MEETING AGENDA
CITY PLAN COMMISSION
Thursday, August 13, 2026

1. FS-26-057 – Alliance Center North Lots 1R and 2R, Block 3, Waiver Request Section 31-106(c)(3) Street Design Standards: Council District 10.

2. FS-26-157 – Union Depot Addition, Waiver Requests Section 31-106(c)(9) Street/Alley Intersection Corner Clips and Section 31-106(g)(2) Alley Width Requirements: 1 Lot, Council District 8.

3. FS-26-167 – ECX South Lot 1, Block 1, Waiver Request Section 31-102(b)(2) Interconnectivity of Neighborhoods: Council District 8.

Plat Exhibit

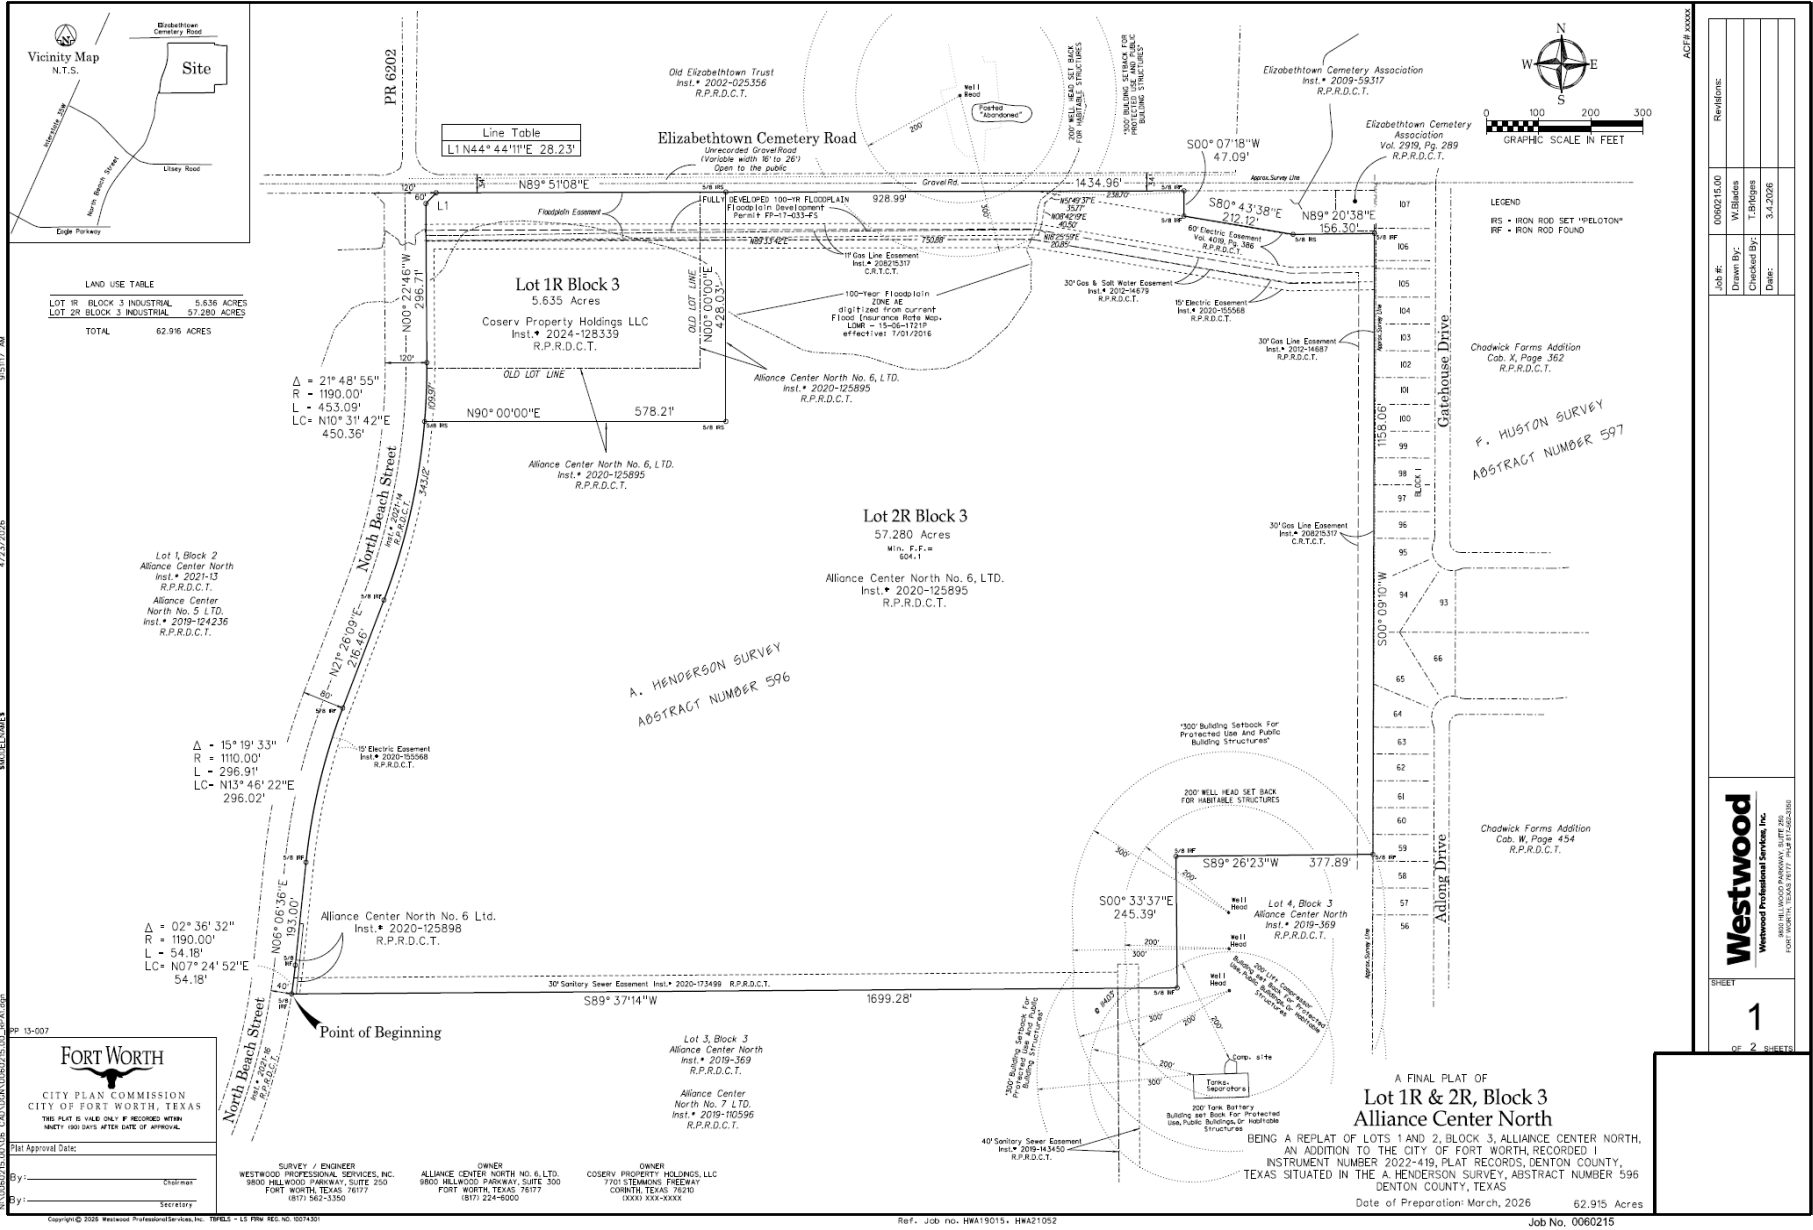
1. FWFD - (Lt. Adam Thornton, FirePlatting@fortworthtexas.gov)
Site plan emailed: 3/31/26
WF opened 5/1/26
Revision: 7/30/26

CLEARED 3/31/26: CORRECTION REQUIRED: Provide a site plan to Fireplatting@fortworthtexas.gov and your case manager with your case number in the subject line.

- HOLD Place case number onto plat: FS-26-057
- CLEARED Provide and label a 10ft x 10ft corner clip at the corner where N. Beach St. & Elizabethtown Cemetery Road intersect. Section 31-106 (c)(9) Street/alley intersection corner clips. A triangular right-of-way dedication (corner clip) measuring ten feet by ten feet, measured at the property line, is required on corner lots at the intersection of two streets or intersection of a street and an alley.

5. CLEARED 5/4/26 SB - ROW/Easement Dimensions - Show the dimensions (including curvature data) of all existing, recorded, or to be recorded ROW including streets, alleys, easements, railroads, or other public ROW within or adjacent to the subdivision boundaries. Include the distance from the centerline of the existing roadway to the proposed property line. Only if necessary, use "variable" and give the range.

HOLD 08/04/26 PP - show the instrument numbers for easements && Correct Flood Study

HOLD 06/23/26 PP - Remove FINAL ISWM REQUIRED RELATED TO SWM-2018-0553 note.

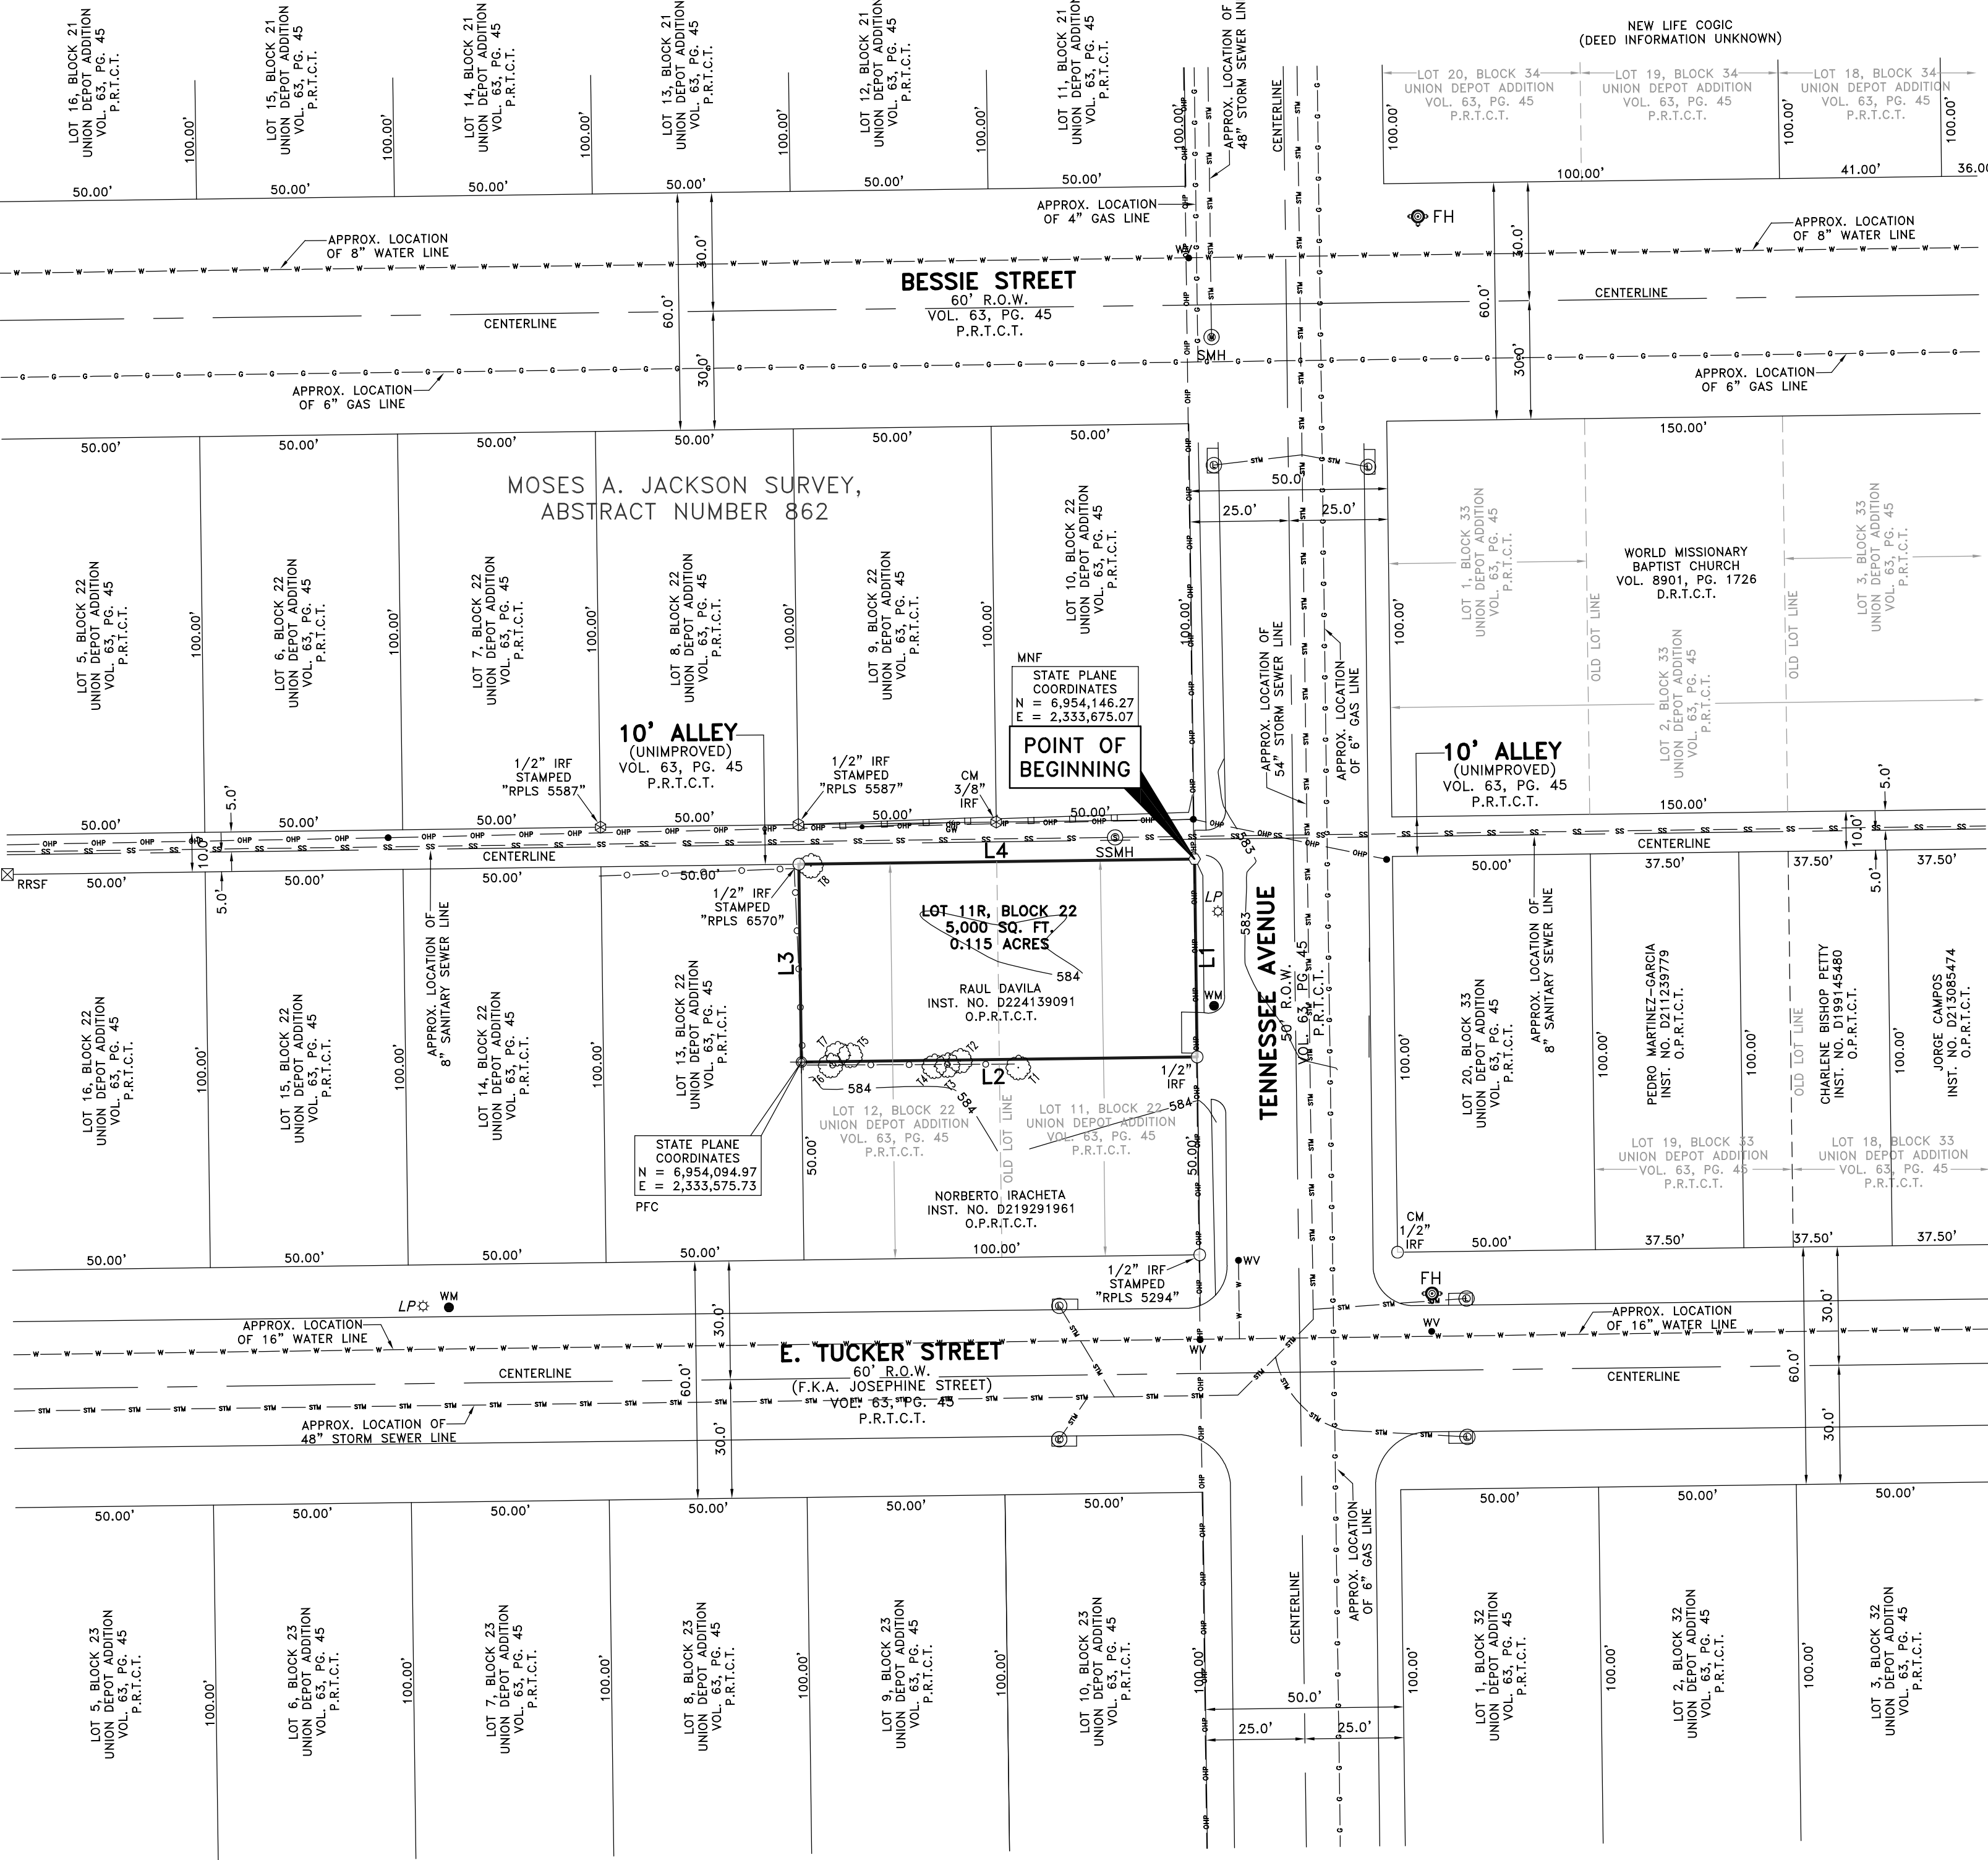
-remove zoning designation from the land use table, just list as residential

-do not show utility lines on the plat, also remove trees, driveways, etc

HOLD 07/29/26 PP - NOTE IS NOT NEEDED. WORDING IS INCORRECT. - FIX OR DELETE

HOLD 07/29/26 PP- NOTE IS NOT NEEDED. WORDING IS INCORRECT. - FIX OR DELETE

2. HOLD – (parent/child relation) cannot connect to water main until the main is accepted by the city (green sheet) AND CFA EXECUTED (Subdivision ordinance §31-63.c.1.b.3)

4. HOLD - Provide a utility site plan that identifies all proposed water and sewer services. Provide an exhibit showing the location of existing water and sewer services (if applicable, any proposed services) based on new property lines and tied down to the nearest property corner. If needed, please field verify. If existing water/sewer services are identified, indicate whether the service will be utilized or abandoned/killed. Any abandonment will require a "Kill Tap" letter. §5.18.1, §6.4.1.3

Scale	Drawn by	Checked by	Date	Project No.	Sheet No.
1" = 200'	SDH	MCB	07/13/2026	068915128	1 OF 2

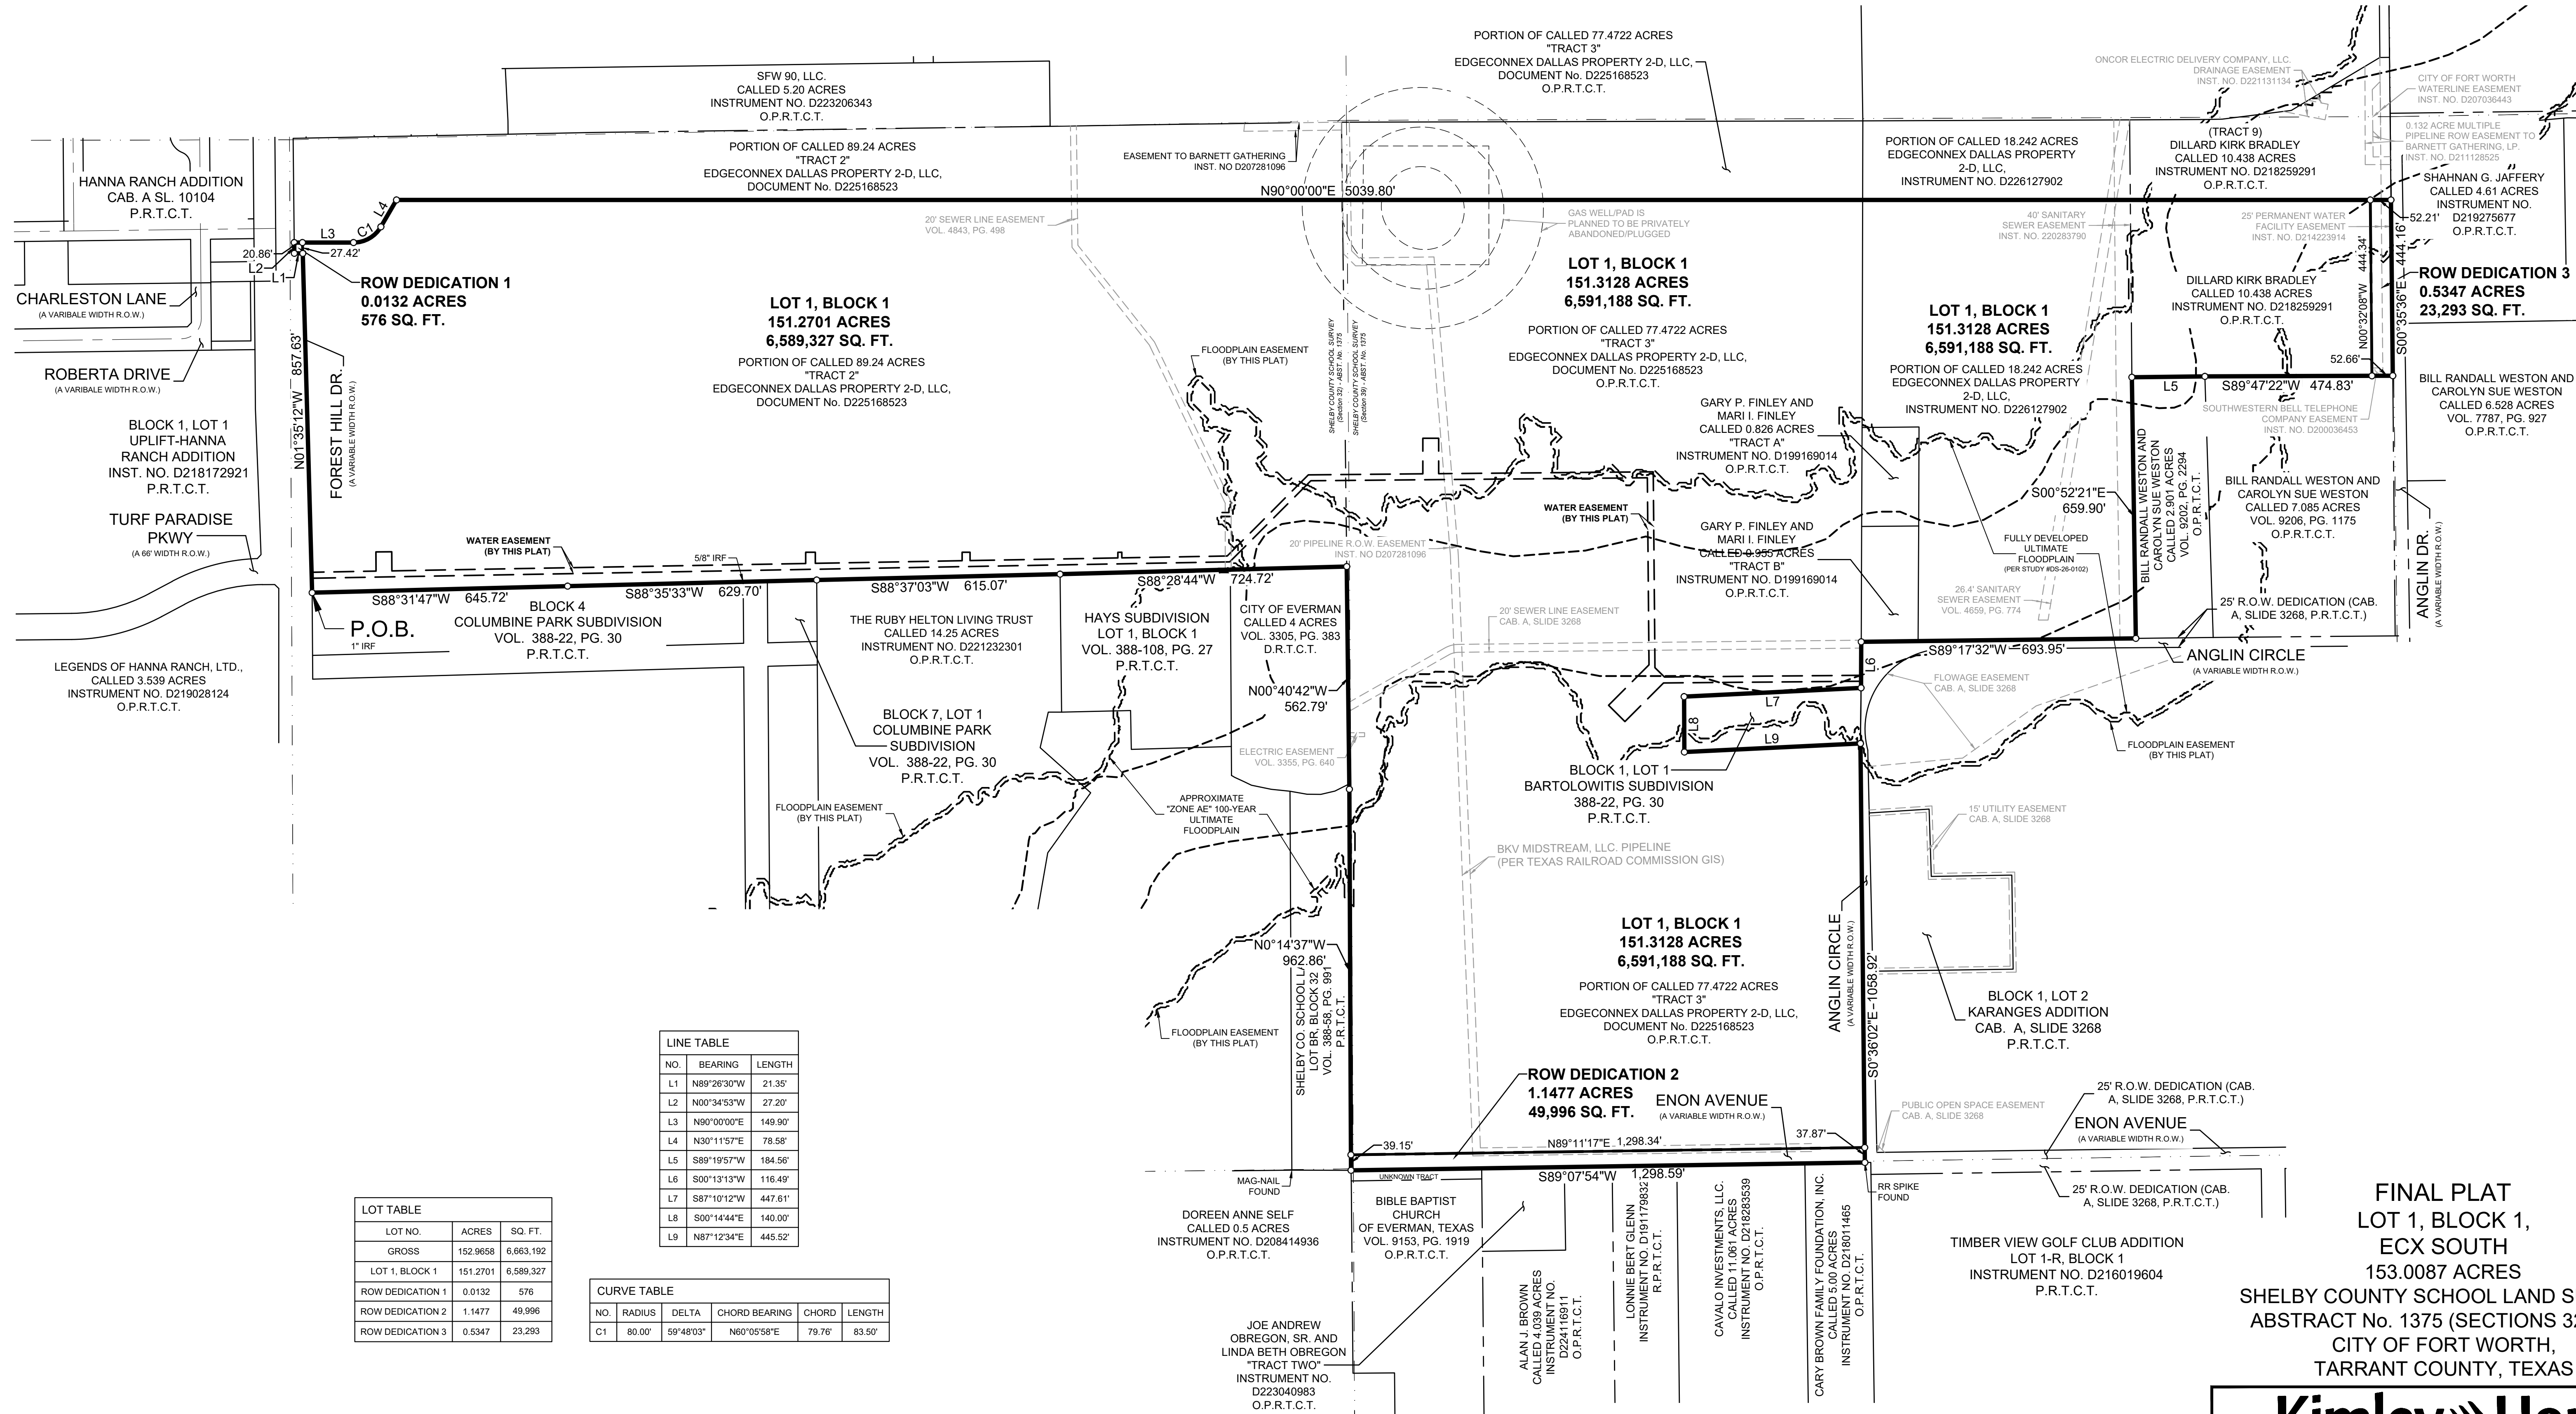
1.HOLD 7/29/26 (ea) – Provide adequate water/sewer exclusive easements to match city-accepted construction plans. (Water and sewer Design §3.8.8.)

*Revise 20" sewer easement to match the recorded sewer easement, a 15" sewer easement VOL 4843 PG 498.

*20" sewer easement that runs vertically through lot, please provide instrument number.

CORRECTION REQUIRED: Change Roberta Drive to Kelso Drive

CORRECTION REQUIRED: Change Charleston Lane to Charlestown Lane

CORRECTION REQUIRED: Change Enon Avenue to E Enon Avenue

Show 300' Building Setback radii from each gas well bore and label:

Show 200' Building Setback radii from each gas well bore and label:

Show 200' Building Setback radii from the Lift Compressor:

Show 5' no build easement around abandoned gas well and label:
